RENESAS TECHNICAL UPDATE

Classification of Production	MPU&MCU		No	TN-SH7-492A/E	Rev	1
THEME	Notice about The MMCIF transfer data block size in multiblock read command.	Classification of Information	1. Spec change 2. Supplement of Documents ③. Limitation of Use 4. Change of Mask 5. Change of Production Line			
PRODUCT NAME	SH7760	Lot No.	Reference Documents	SH7760 hardware manual (ADE-602-291)	Effective Date	
		All			Eternity

figure.1 Timing of receiving the command response and data

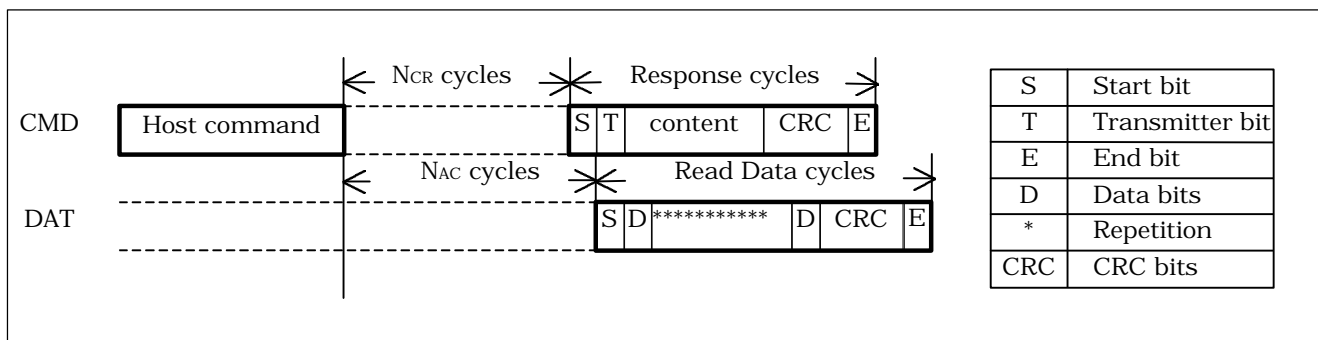
The MMCIF may not receive the command response correctly, when it finishes receiving the end bit of the first data block before receiving the end bit of the command response. It may occur after MMCIF sends CMD18 to the receive device.

- (1) The multiblock read command (CMD18) is sent.
- (2) The transfer data block size is setting to 1,2,4 or 8 byte(s).
- (3) The end bit of the command response is received after the end bit of the first data block is received.

- (2) Confirm that the end bit of the command response is received before the end bit of the first data block is received, if the transfer data block size is 1,2,4 or 8 bytes when CMD18 is transmitted.

Keep the below formula in order to confirm that the end bit of the command response is received before the end bit of the first data block is received.

$$\text{NAC cycles} + \text{Read Data cycles} > (\text{NCR Cycles} + \text{Response cycles})$$

- (1) The transfer data block size in Transfer Byte Number Count Register (TBCR) must be more than 16 bytes when CMD18 is transmitted.
